Access Compliance Report

Public Rights-of-Way

(Curb Ramps)

Intersection ID: 16269	Main Street: STERLING_RD	Cross Street: WELLESLEY_AV	Location: SE
ADA ID: 21E7EEA8EA81	Ramp Type: PerpDiag	Initial Pass/Fail: Fail	Overall Compliance: No
Codes/Mitigation Info/Possible Solution		Field Measurements/Component Compliance	
Severity Score: 25

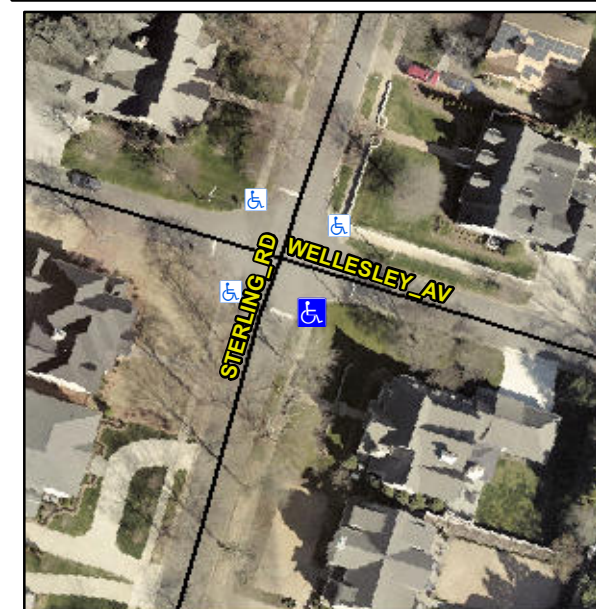
Not Found, R304.2.2, R304.5.3

Compliance	Description	Data	Compliance	Description	Data
N/A	Ramp Length (in)	47.0	No	Ramp Slope (%)	8.6
Yes	Ramp Width (in)	48.0	No	Ramp XSlope (%)	6.1
N/A	Flare Type LT	N/A	N/A	Flare Type RT	N/A
N/A	Flare Slope LT (%)	N/A	N/A	Flare Slope RT (%)	N/A
N/A	Flare Traversable LT?	N/A	N/A	Flare Traversable RT?	N/A
N/A	Landing Length (in)	N/A	N/A	DWS Provided?	N/A
N/A	Landing Width (in)	N/A	N/A	DWS Contrast?	N/A
N/A	Landing Slope (%)	N/A	N/A	DWS Length (in)	N/A
N/A	Landing X Slope (%)	N/A	N/A	DWS Full Width?	N/A
N/A	Landing Curb? (Y/N)	N/A	N/A	DWS Offset (in)	N/A
N/A	Shared Landing?	N/A			
N/A	Gutter Ponding?	N/A	N/A	Gutter Slope (%)	N/A
N/A	Gutter Lip Ht (in)	N/A	N/A	Gutter X Slope (%)	N/A
N/A	Painted X Walk1?	No	N/A	Painted X Walk2?	No
	X Walk 1 Direction	To NE		X Walk 2 Direction	To NW
N/A	X Walk 1 Width (in)	N/A	N/A	X Walk 2 Width (in)	N/A
	X Walk 1 Slope (%)	4.2		X Walk 2 Slope (%)	3.9
	X Walk 1 X Slope (%)	0.8		X Walk 2 X Slope (%)	5.8

N/A	Ramp inside XWalk1?	N/A	N/A	Ramp inside XWalk2?	N/A
	Road Slope (%)	4.5	N/A	Clear Space?	N/A
	Road X Slope (%)	11.3	N/A	Clear Space to XWalk (in)	N/A
N/A	Any Obstructions?	N/A	N/A	Storm Grate/Utility Hazard?	N/A
	Obstruction Type			Storm Grate/Utility Type	
		N/A			N/A
			Yes	Surface Condition? (G/P)	Good

Remove & Replace Curb Ramp With Two New Directional Ramps or Equivalent.
